RE: 7001 Signal Ave. Allergy Clinic
Grading and Drainage Plan
Engineer's Stamp Date 1-31-2017 (File: C19D065)

Based upon the information provided in your submittal received 2-6-2017, the above referenced Grading and Drainage Plan is approved for building permit and SO-19 permit with the following conditions:

CITY OF ALBUQUERQUE
PUBLIC WORKS DEPARTMENT
ENGINEERING DEVELOPMENT GROUP
7001 SIGNAL AVE. N.E. - ALLERGY CLINIC
GRADING AND DRAINAGE PLAN

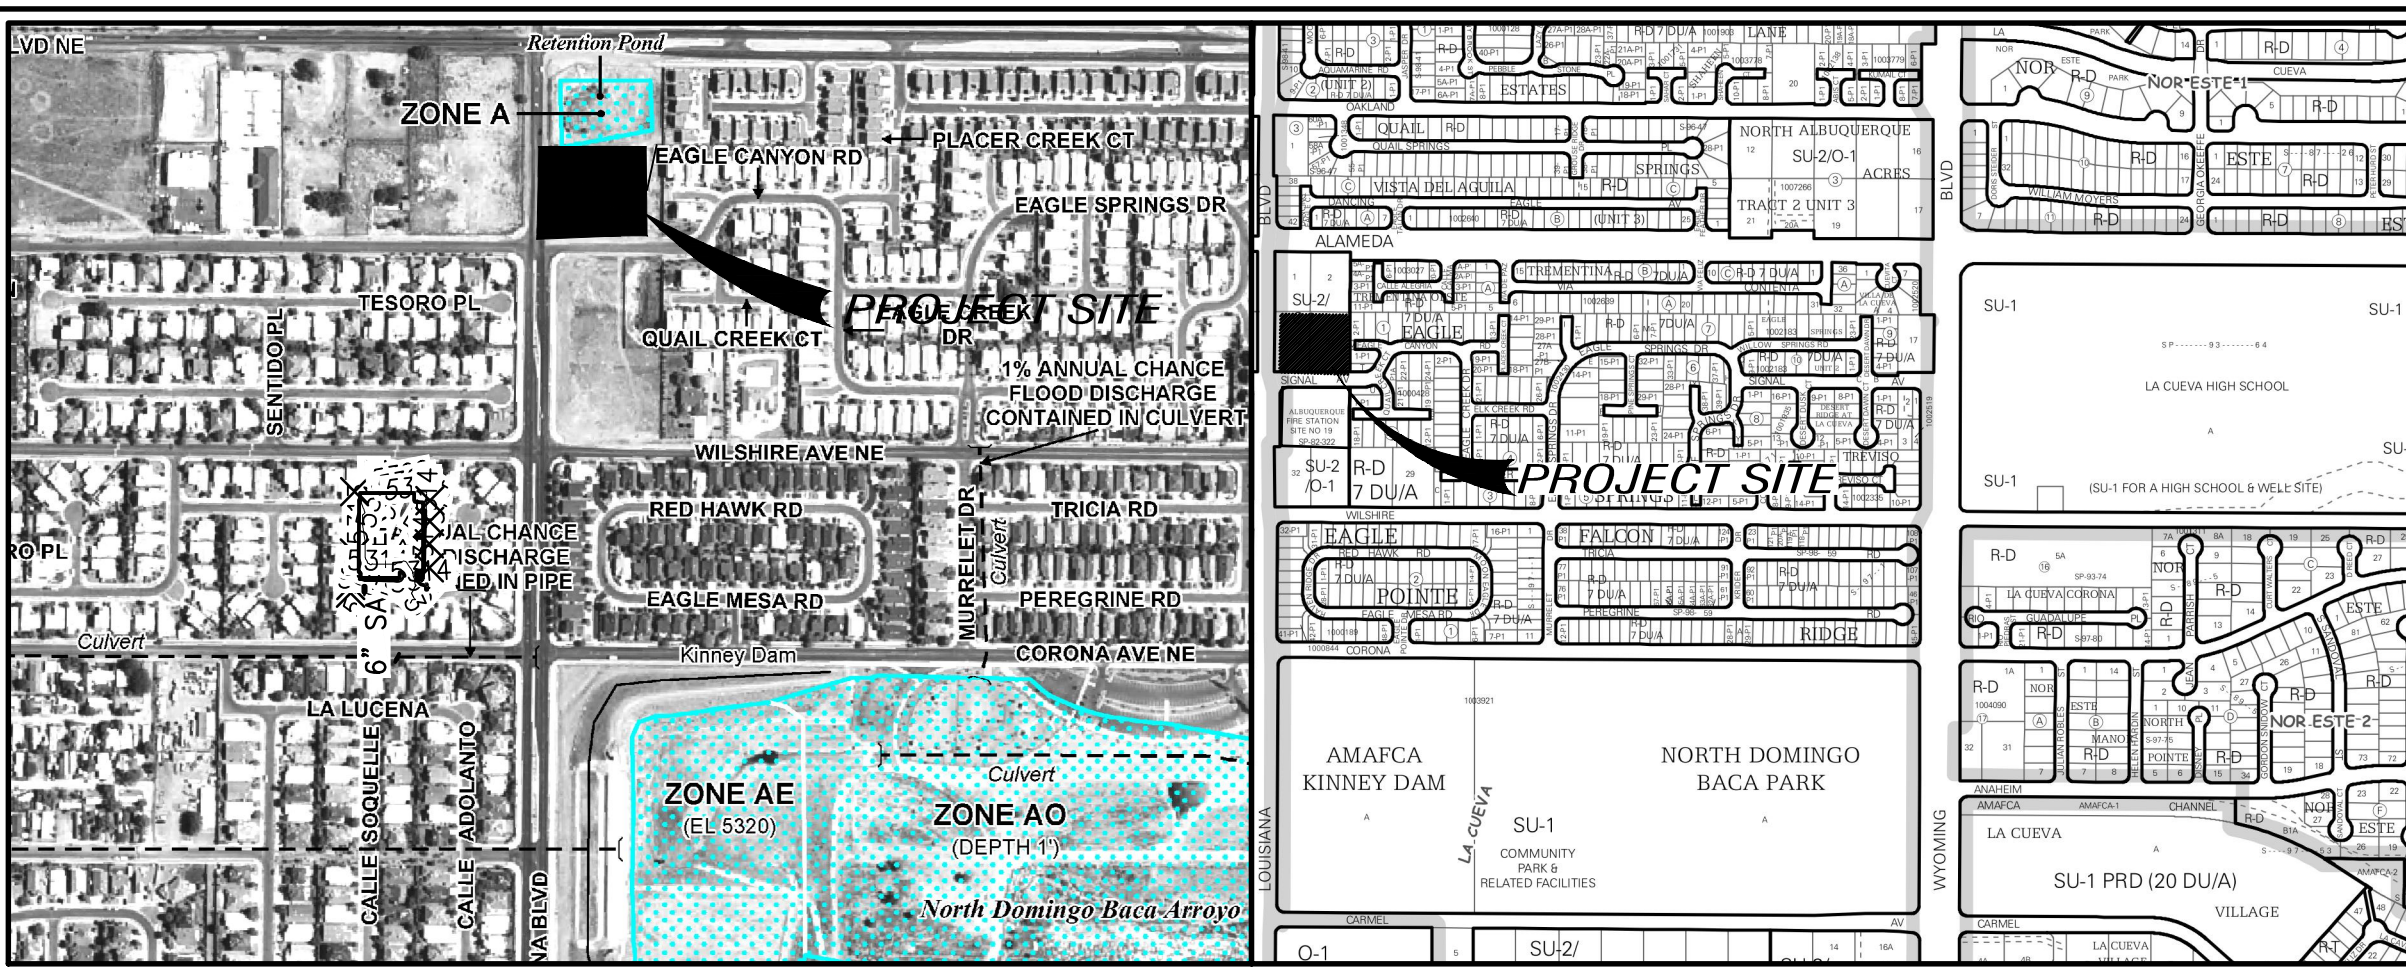
1. Extend the sidewalk culvert plus plate 12 inches passed property line.
2. Please make sure sign shown at the southwest corner of Louisiana and Signal will not create clear sight distance issues.
